# 3rd & Cherry

DESIGN REVIEW BOARD  
2<sup>nd</sup> RECOMMENDATION MEETING

Project Address: **601 4th Avenue**  
SDCI Project #: **3028747**

View of Cherry Street from 4th avenue

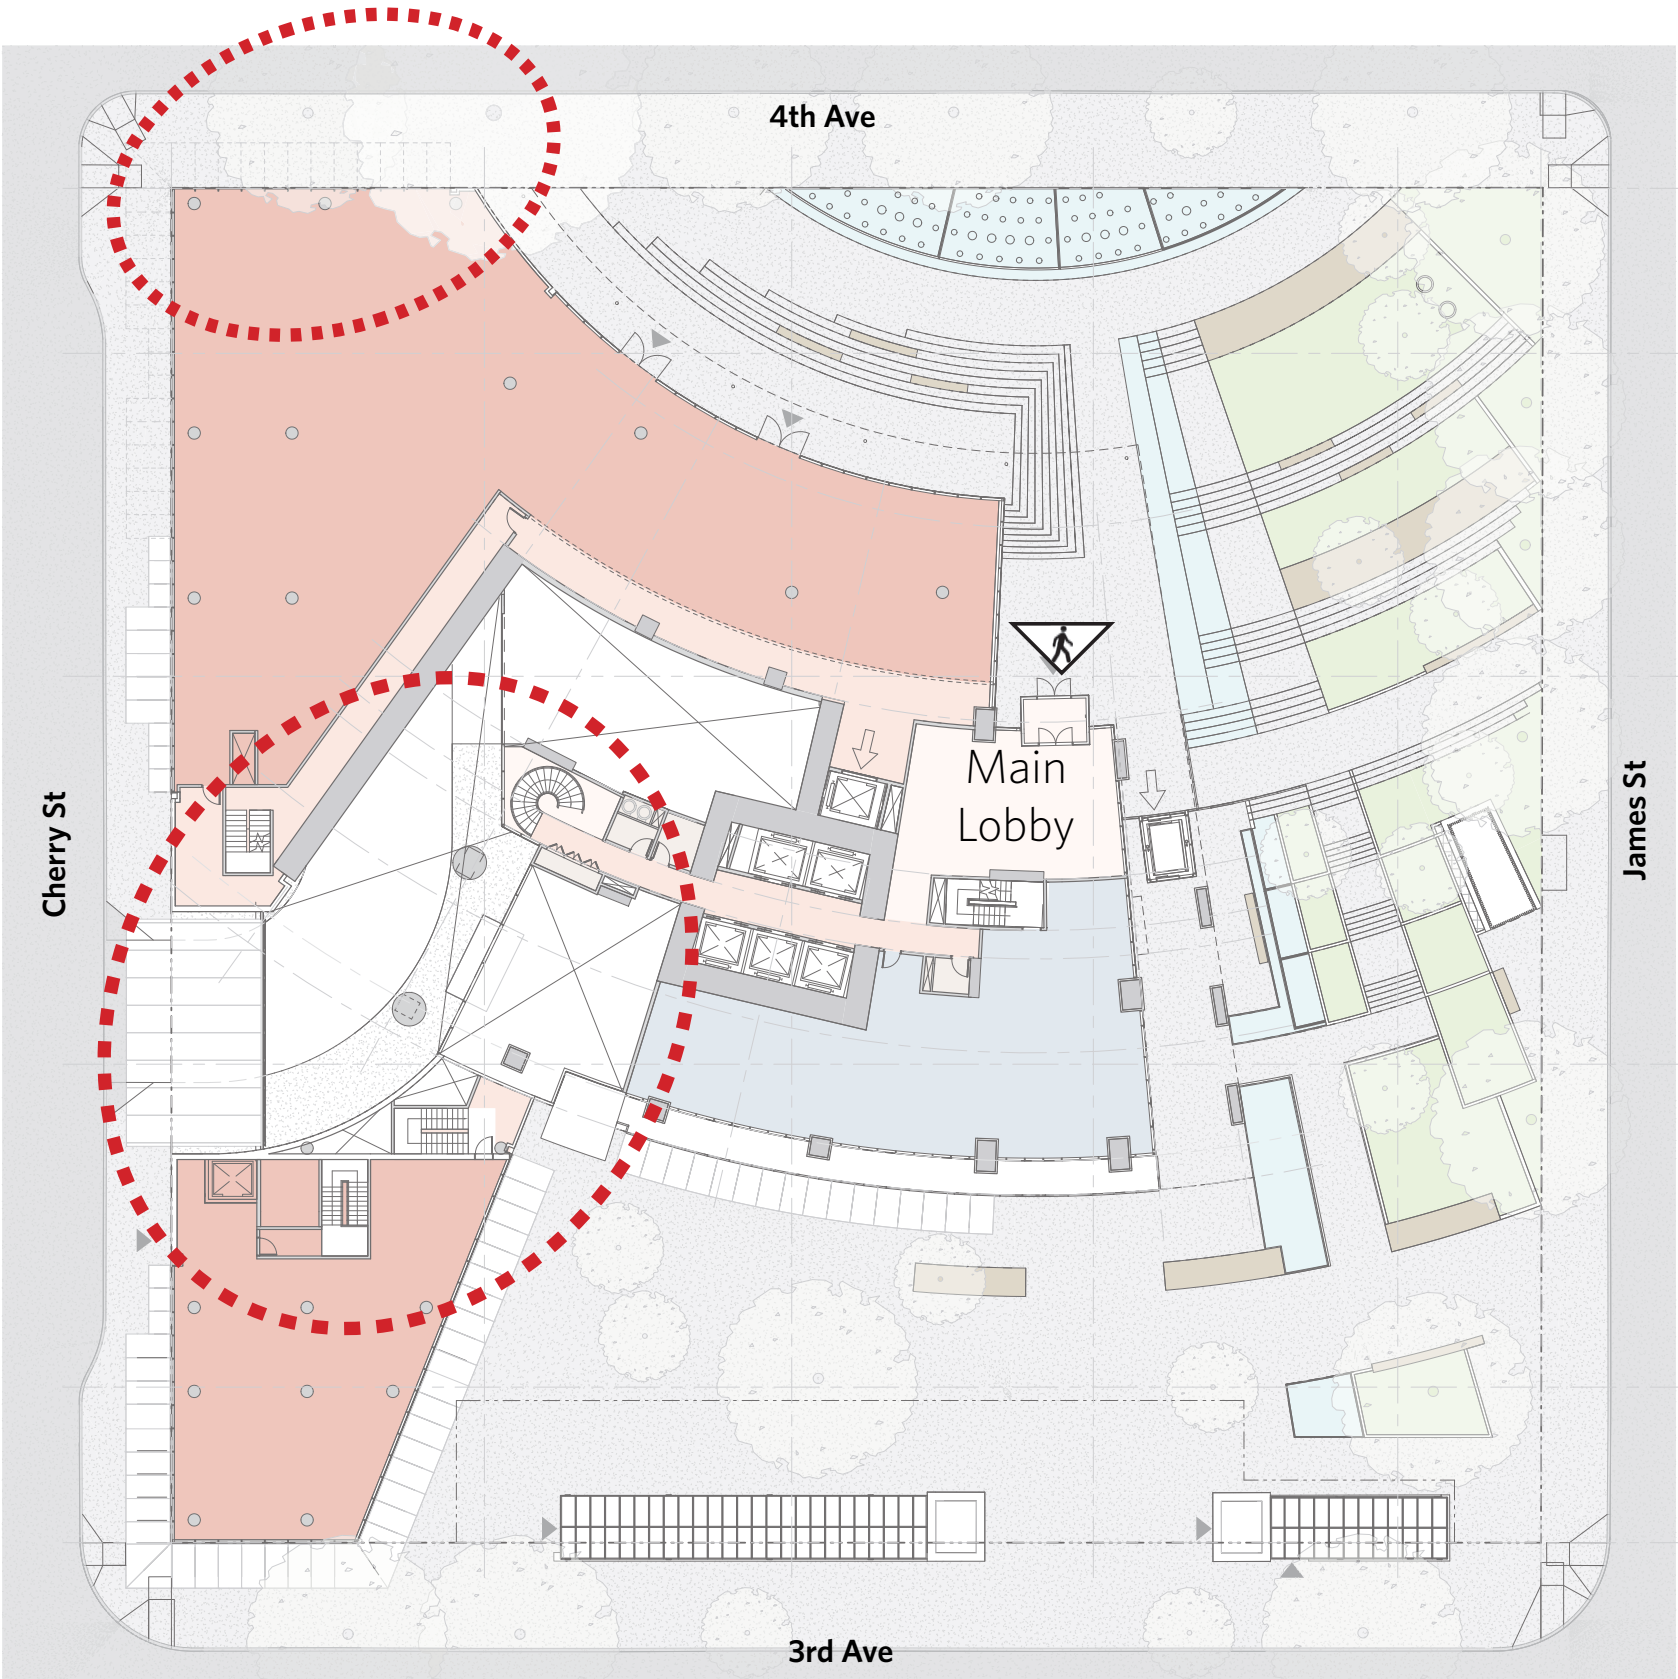
a. Provide activation along the Cherry St. façade with operable windows, doors if possible, and resting/seating areas. (C3.1.b, C3.1.i)

The corner of 4th Avenue and Cherry Street has been activated by providing an entrance into retail from this area.

Seating areas have been added mid-way up Cherry Street.

Level 1 Plan Arrival Plaza

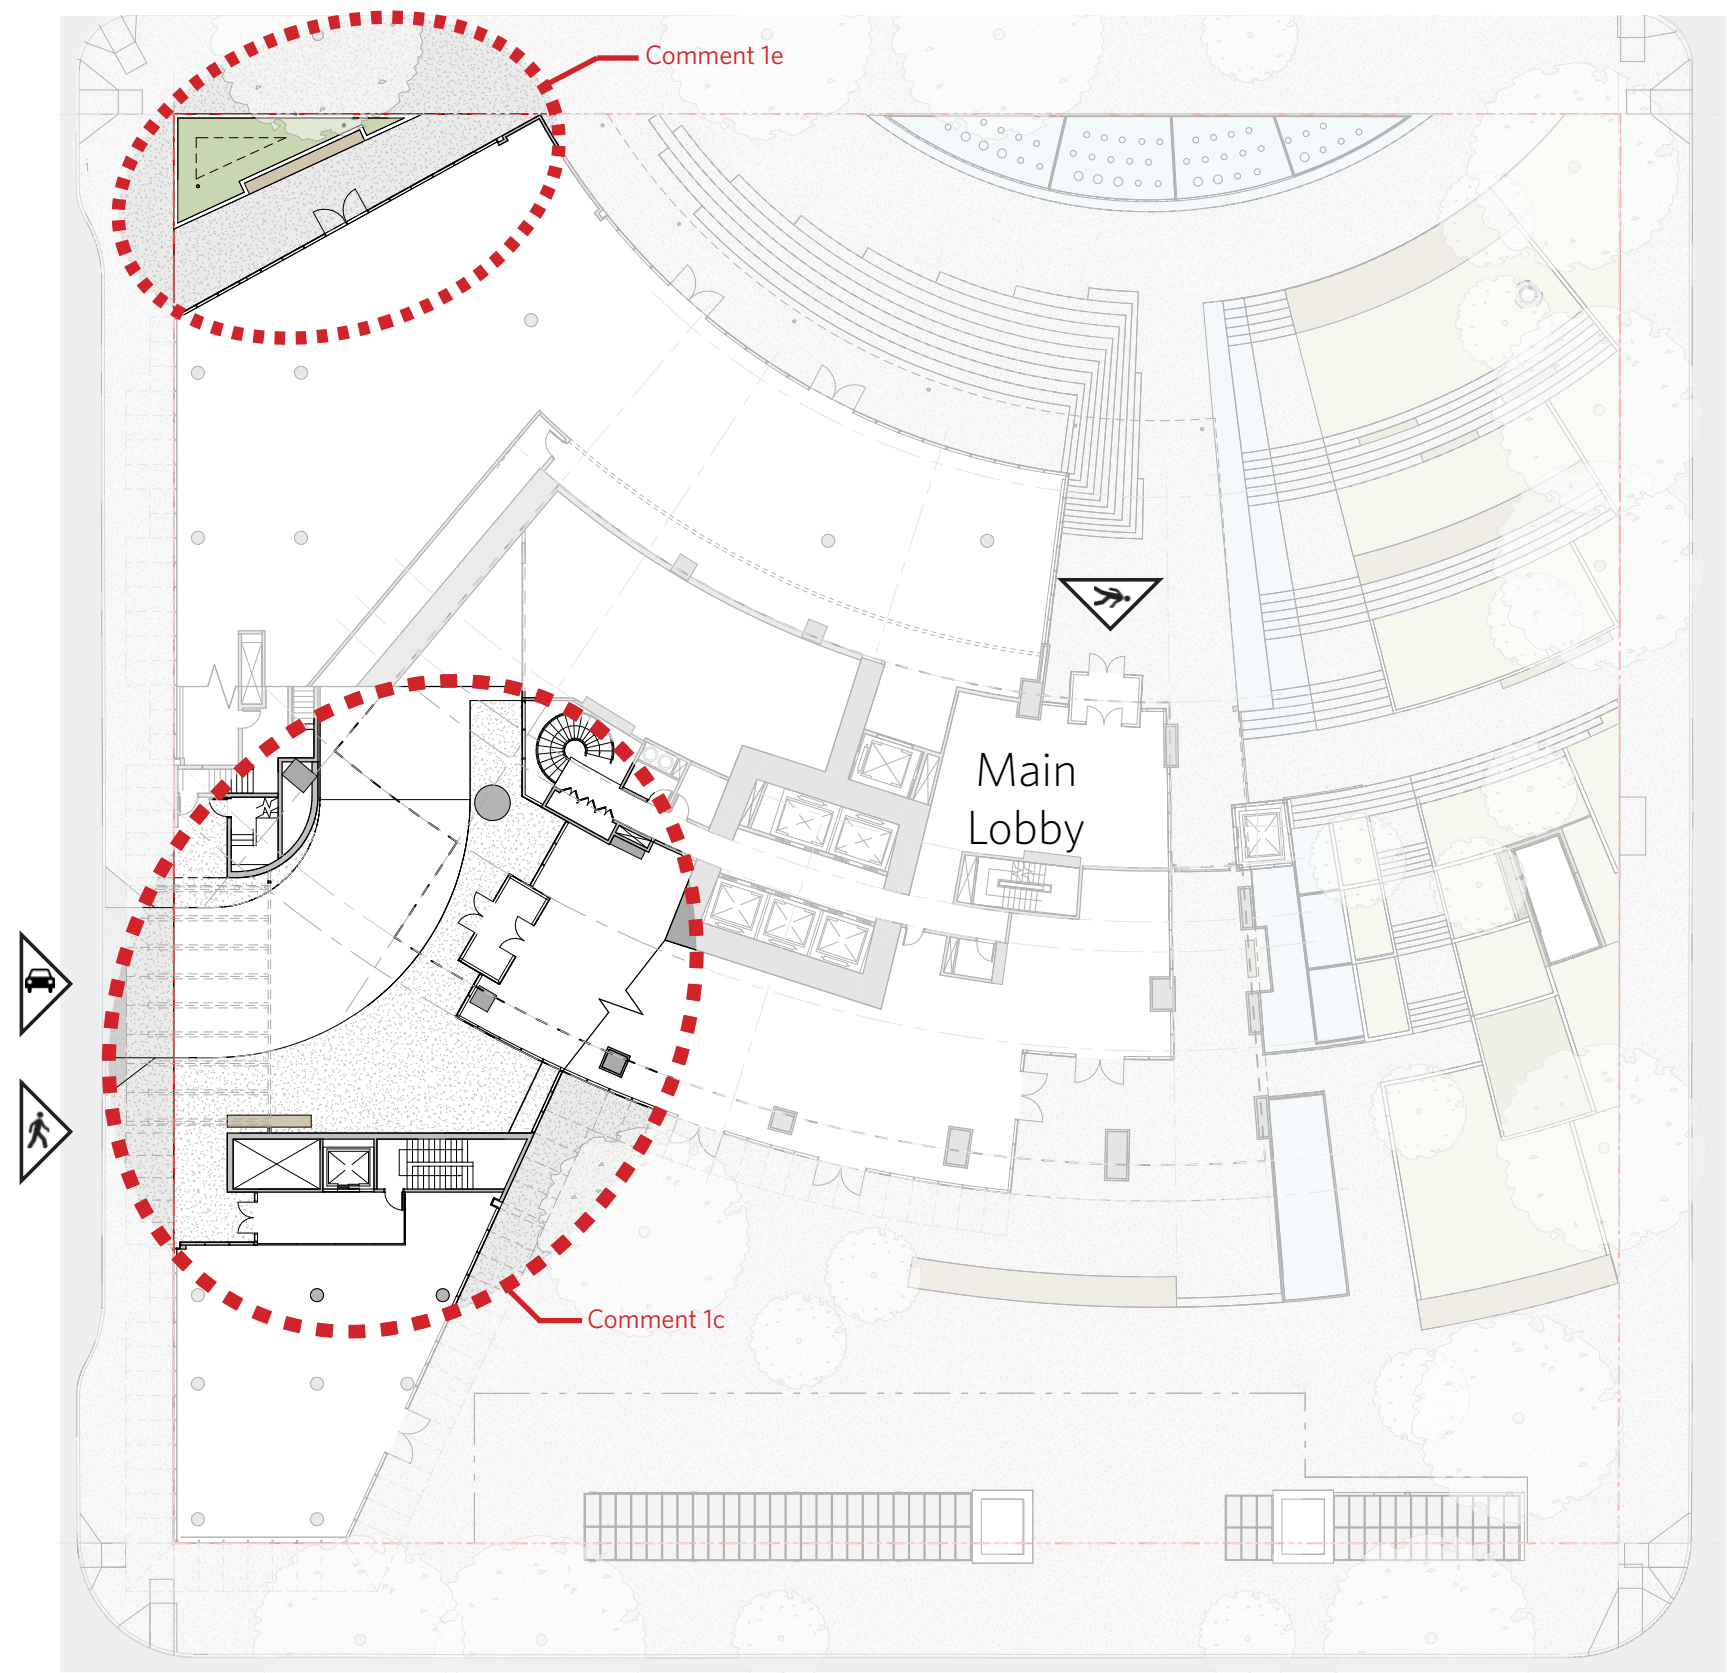
b. Provide a continuous canopy or recesses that provide weather protection for the length of the street. (C5)

A canopy has been added to the face of the stone adjacent to the arrival plaza as per the boards request.

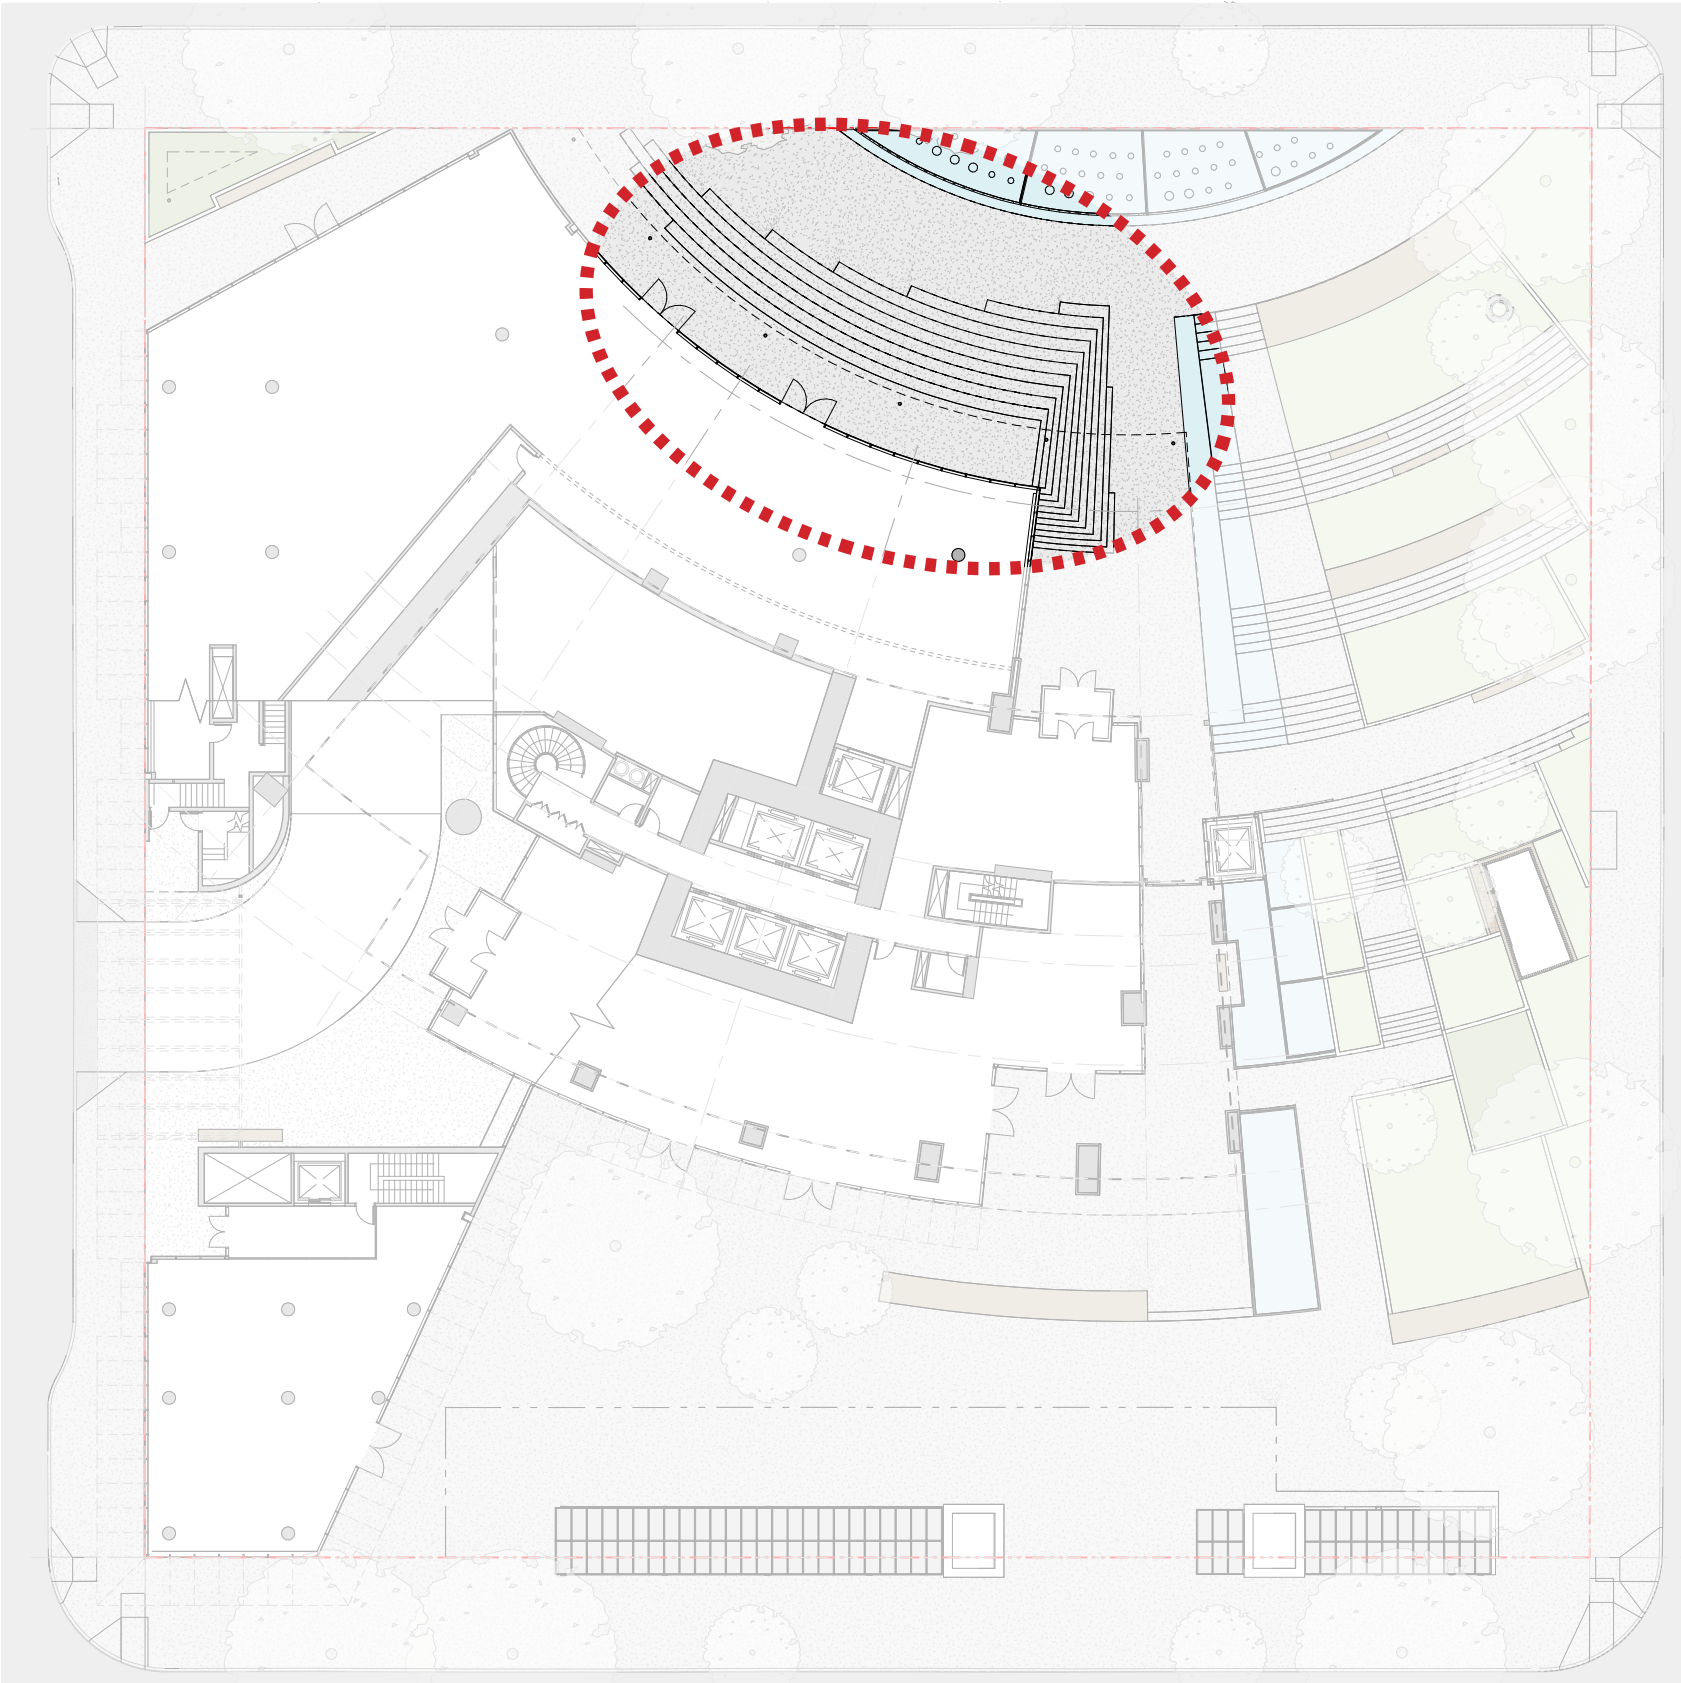
The Board gave guidance that the curved steps at the upper plaza facing 4th Ave need to be designed so that sitting on them will be comfortable. (D3.1.f)

The stairs tread depths will be a minimum of 18" deep, to accommodate seating.
